NUMBER
231 (Rev 1, 04/28/2021)

TECHNICAL SERVICE BULLETIN

**FRONT VIEW CAMERA REPLACEMENT
FOR DTC C160449 & C160649**

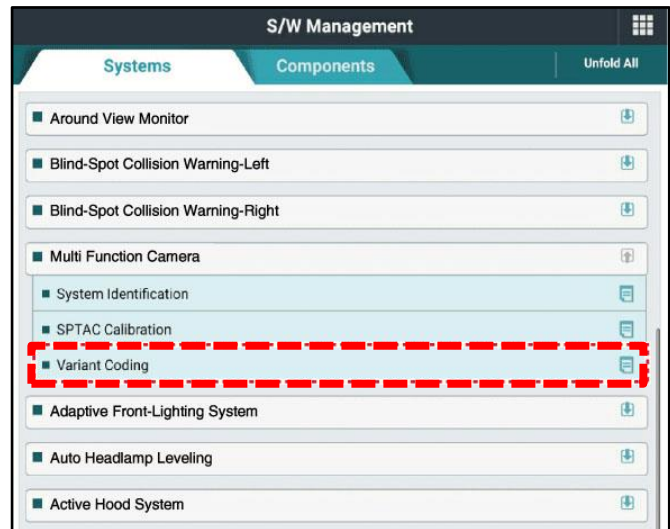
1. Remove and replace the Front View Camera (A) by referring to the “Body Electrical System → Front Camera System → Front View Camera Unit → Repair Procedures” chapter in the applicable Shop Manual on KGIS.

2. Perform the “Variant Coding” procedure by referring to the “Body Electrical System → Front Camera System → Repair Procedures” chapter in the applicable Shop Manual on KGIS.

After replacing the front camera with a new unit, the Variant Coding procedure must be performed.
